Groundwater Transfer Review Summary Form

Transfer/PA # T- 14354

Application: T-14354 Applicant Name: Randy Kruse/ Kruse Family Development Company, LLC

1. Basic description of the changes proposed in this transfer: The applicant proposes to change the place of use on Certificate 80626 of 121.01 acres and the POA for those acres to a new proposed well located approximately 4.5 miles to the northwest of the currently authorized POU/POA. The currently authorized POA are Well #1 (LAKE 340), Well #3 (LAKE 341) and Well #4 (LAKE 309/310*).

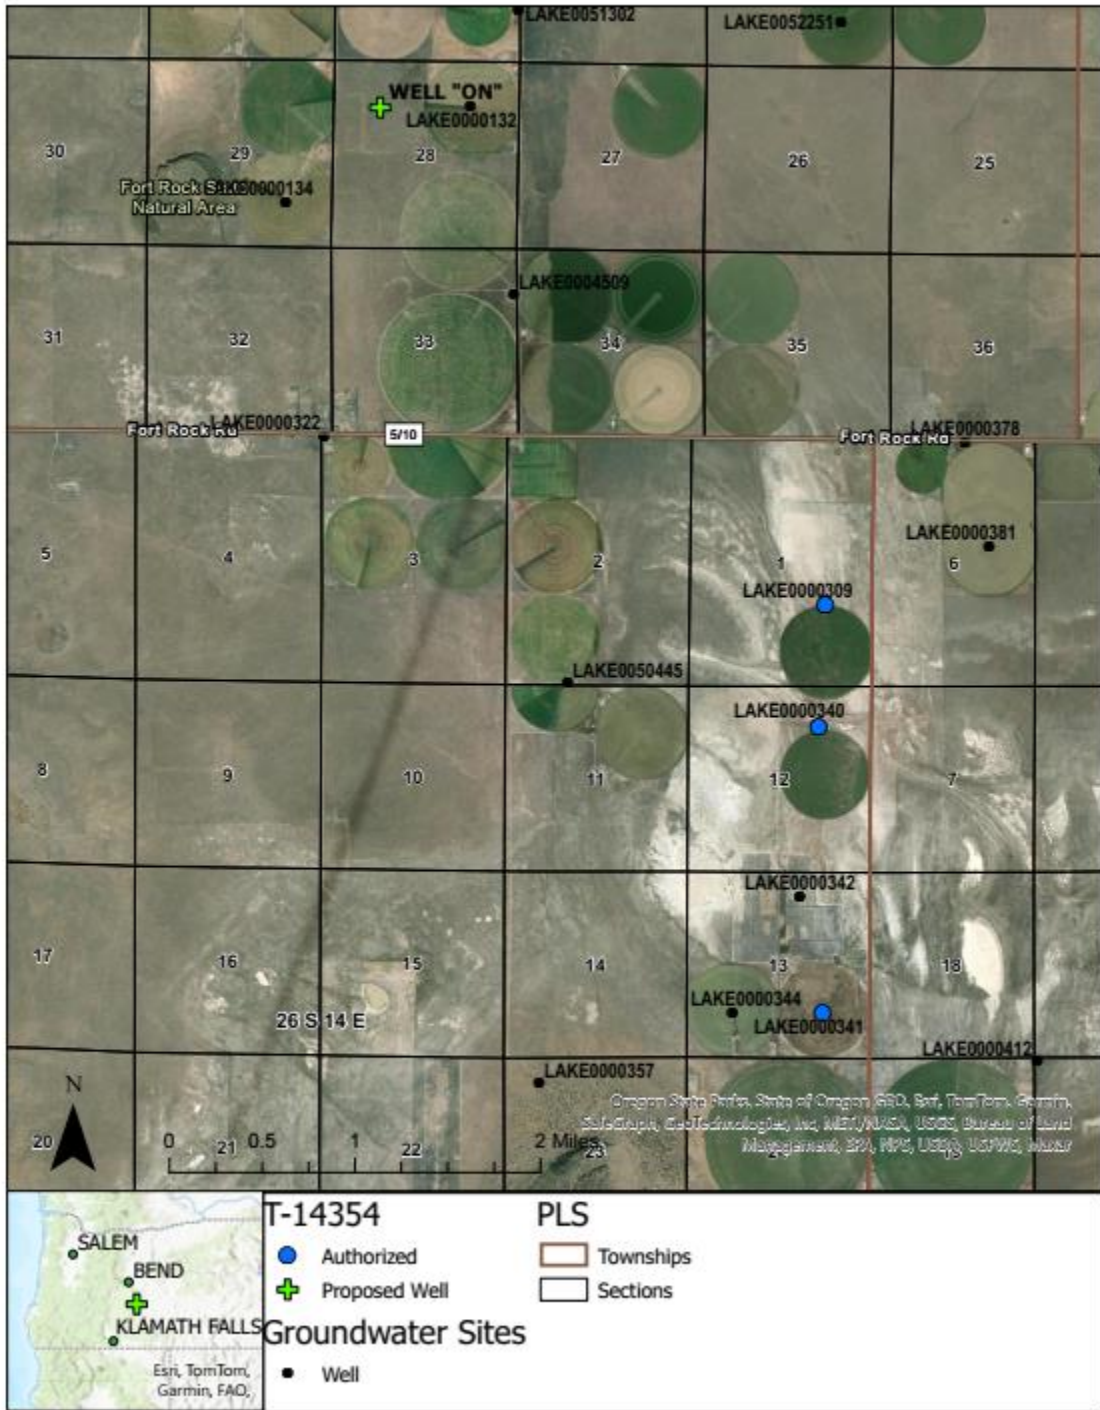
Will the proposed POA develop the same aquifer (source) as the existing authorized POA?
 Yes No Comments: Groundwater in the Fort Rock Valley-Christmas Valley area (Fort Rock Classified Area) is identified as a single groundwater system. Groundwater is found in both a shallower predominantly basin-fill sediment unit and a deeper predominantly volcanic rocks and sediments unit below. The predominantly basin fill sediment unit and the predominantly volcanic rocks and sediment unit both readily yield groundwater, and the two units are hydraulically connected.

Miller (1986) describes the groundwater source as the main groundwater reservoir. That reservoir includes groundwater in different geologic units. The reservoir has three characteristics. First, the “natural” groundwater level changes less than 1.5 feet annually, indicating the system is highly modulated. Second, the 1980s potentiometric surface was approximately 4292 feet elevation amsl basin-wide with Silver Lake an exception. Third, the reservoir consists of numerous water producing zones in several formations, all having an essentially common potentiometric level, and all being very transmissive in general.

The authorized wells produce groundwater from water bearing zones within the predominantly basin-fill sediment and/or the underlying predominantly volcanic rocks and sediment unit of the main groundwater reservoir. The proposed well (WELL “ON”) will also produce groundwater from water bearing zones within the main groundwater reservoir.
